Product/Process Change Notification / PCN

PCN Title Replacement 9432-9435 to 12326-12329 USB cables 1-8m

PCN No. 2019-07-22 **PCN Issue date** 2019-07-22

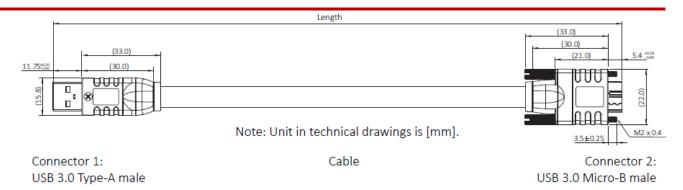
The new cables change in fit & form, as the cable diameter and dimensions and design of the connectors change. The new cables offer a metalized connector housing and a separate adapter to screw-lock the USB 3 host connector. Please refer to the following drawings for the details:

length	old order code	diameter	new order code	new diameter
1 m	9432	5.5 mm	12326	6.2 mm
3 m	9433	5.5 mm	12327	6.2 mm
5 m	9434	5.5 mm	12328	6.2 mm
8 m	9435	5.5 mm	12329	8.0 mm
